**Subject** ▶ Change of swich

**For Models** ▶ HR2410, HR2420(24mmRotary Hammers)

**Description** ▶ As illustrated below, Swich and Motor Housing have been changed for improvement of endurance

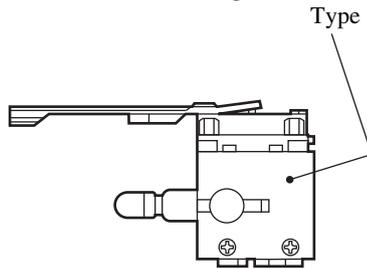
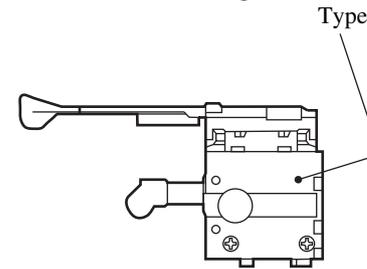
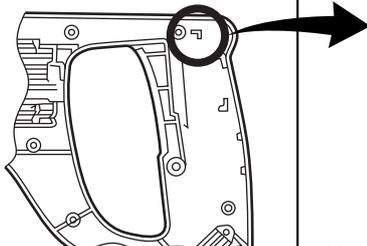
CURRENT	NEW
Swich	Maker :EATON Type :8653B711W(100/115V) 8653C711X(200Vor higher) 	Maker :EATON Type :J1MK700W(100/115V) J2MK711X(200Vor higher) 
Motor Housing (Change of rib)	 Rib When you use new swich, please cut the rib off.	 Rib
